FILE P. I. No. M002969, Muscogee-Troup-Harris Counties **OFFICE** Preconstruction
CSNHS-M002969
I-185 Milling and Resurfacing **DATE** January 2, 2007
FROM *John K. Rice* Genetha Rice-Singleton, Assistant Director of Preconstruction
TO *for* SEE DISTRIBUTION

SUBJECT APPROVED PROJECT CONCEPT REPORT

Subject: Project CSNHS-M002-00(969)
Muscogee/Harris/Troup Counties
I-185 Milling and Resurfacing Concept Report

PROJECT CONCEPT REPORT

EXISTING 4-LANE SECTION

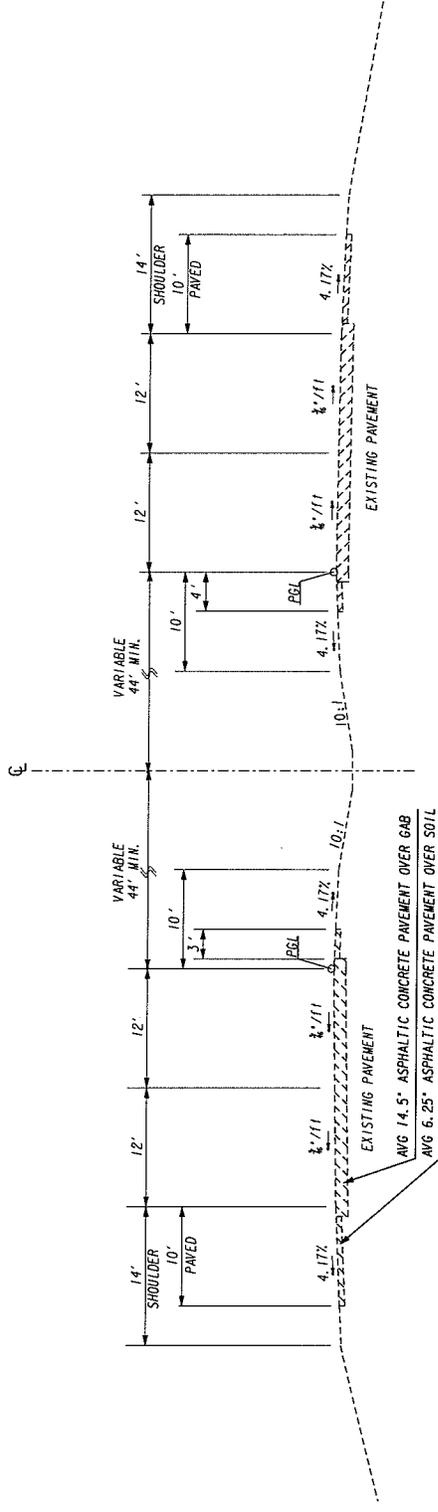
2. In the 4 lane section the 3' inside shoulders do not meet the Jan 05 AASHTO guidance. Would it be possible to push the mainline out 1' into the 14' (10' paved) outside shoulder to obtain 4' paved inside shoulders? Of course we would still need 10' paved outside shoulders.

2. In the 4 lane section the 3' inside shoulders do not meet the Jan 05 AASHTO guidance. Would it be possible to push the mainline out 1' into the 14' (10' paved) outside shoulder to obtain 4' paved inside shoulders? Of course we would still need 10' paved outside shoulders. See response for No. 1.

PROPOSED TYPICAL 4-LANE SECTION

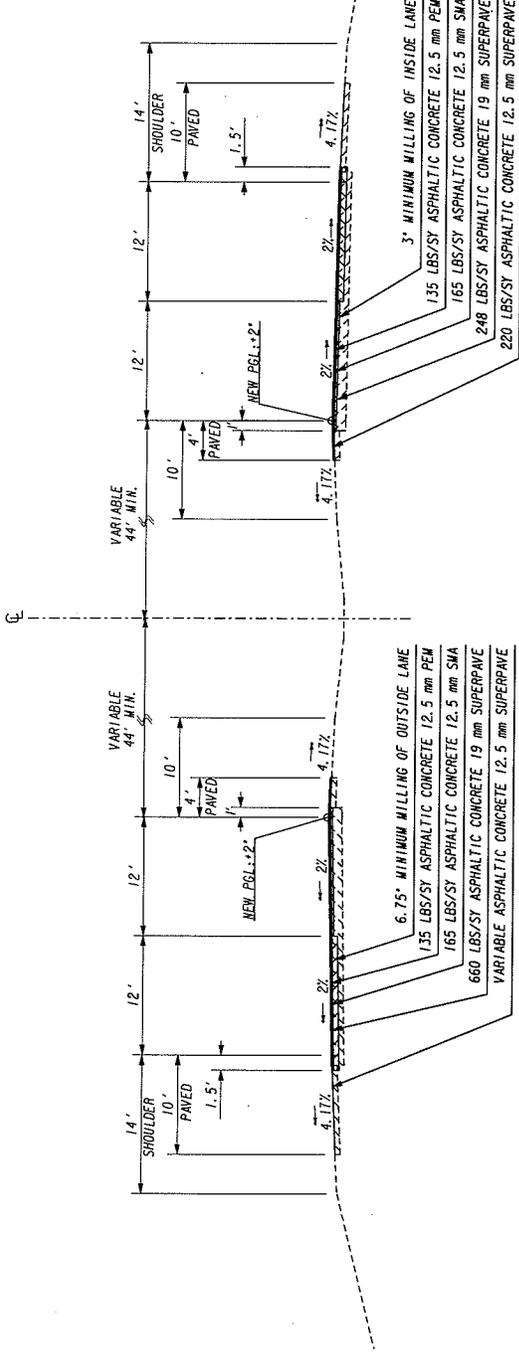
3. The existing cross slope is 3/16ths inch per foot. While I have heard it discussed and seen it in the notes I have not seen that changing cross slope from 3/16ths to 1/4 inch per foot is a part of this project. Could we make it a part of this project?

3. The existing cross slope is 3/16ths inch per foot. While I have heard it discussed and seen it in the notes I have not seen that changing cross slope from 3/16ths to 1/4 inch per foot is a part of this project. Could we make it a part of this project? The proposed typical sections on the concept report indicate a cross slope of improvement from 3/16"/ft to 2%.

10. Thomas wanted to clarify that the inside shoulder would match PGL raised by 2" and build up to adjust cross slope on tangent sections of existing travel lanes from 3/16" per foot, to 2%. It was agreed that inside shoulder be raised 2" as well and slope is adjusted to match slope of travel lanes. That would only be possible in depressed median sections and not in the urban sections with paved shoulder and median barrier.
